WELL API NO.	30-015-24144
5. Indicate Type of Lease	STATE <input type="checkbox"/> FEE <input checked="" type="checkbox"/>
6. State Oil & Gas Lease No.	
7. Lease Name or Unit Agreement Name	Pardue 30 Com
8. Well Number	1
9. OGRID Number	296278
10. Pool name or Wildcat	SWD; Bell Canyon-Cherry Canyon (96802)
11. Elevation (Show whether DR, RKB, RT, GR, etc.)	3089.3' GR

Re: Variance Request for Probity SWD, LLC's Pardue 30 Com No.1 SWD as Permitted with Conditions by Division Order SWD-1585.

Administrative Order SWD-1585: Request for Change in Conditions of Approval

RE: Administrative Order SWD-1585; Pardue 30 Com. SWD No. 1 (30-015-24144); UL E, Sec 30, T23S, R28E, NMPM

PROPOSED CONFIGURATION

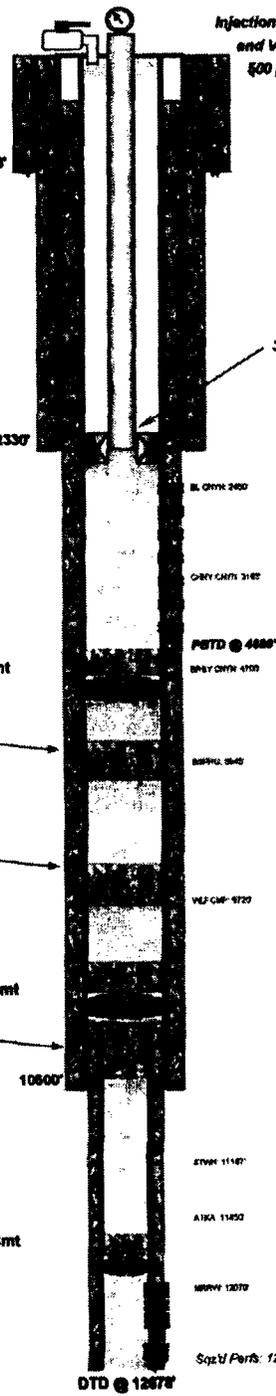
SWD-1585 came with the condition of running a cement bond log from the top of the 4-1/2 inch liner continuing to whatever depth the top of cement is determined to be behind the 7-inch production casing string. The well file indicates that the 7-inch casing was set with 1375 sacks of Class H Neat cement. In an 8-1/2" hole, this volume was apparently calculated to push well above the intermediate casing shoe depth of 2330 feet although, the top of cement was not reported nor did it circulate. We therefore understand the need to determine if adequate cement exists behind as well as above and below the proposed interval. However, with the long extent of pipe below the proposed interval down to the original producing interval, it's difficult to see that there is a compelling reason to log such a long interval.

We would therefore like to propose the following (rigged up, tubulars pulled and well killed):

- 1) Set a cast iron bridge plug to isolate the perforations below 12,000 feet and cap with 35 sacks of cement.*
- 2) Run a cement bond log from approximately 5100 feet to 2000 feet. This would determine the cement bond approximately 500 feet ABOVE and BELOW the proposed interval. CBL logging intervals may be extended after initial evaluation.*

- 3) Once the cement issue is resolved by logging and squeezing if necessary, continue with configuring the wellbore by loading the hole with plugging mud (minimum 9.5#), cement plugs will be spotted at the depths previously approved on the C-101 dated January 11, 2017 to properly plug the lower portion of the well.*

- 4) Set CIBP at 4750 feet and cap with 35 sacks cement; finish with usual SWD set up and configuration per SWD-1585 and the C-101; perforate & acidize; run packer and tubing, conduct mechanical integrity test with OCD to witness, etc.*

The Division is in receipt of your client's request for the change in the condition of the administrative order regarding the logging of cement for the referenced well. I have discussed this request with the District Geologist along with staff of the Engineering Bureau and the Director. The Division shall approve Probit's request for logging the only the injection interval as long as the cement bond log is of good quality and includes the top of cement for the 7-inch casing. This log would provide documentation of the well's integrity should concerns be raised later regarding this well's disposal operation in the Delaware Mountain Group. All other conditions and requirements as provided in the administrative order (including proposed re-entry and final completion of the well) remain in full force and effect, and are subject to approval by the District prior to implementation.

Since an amended order will not be issued, this e-mail correspondence will serve as approval of the change for the logging requirement and shall be made part of the administrative record (well file and administrative order). Please contact me with any questions regarding this matter. PRG
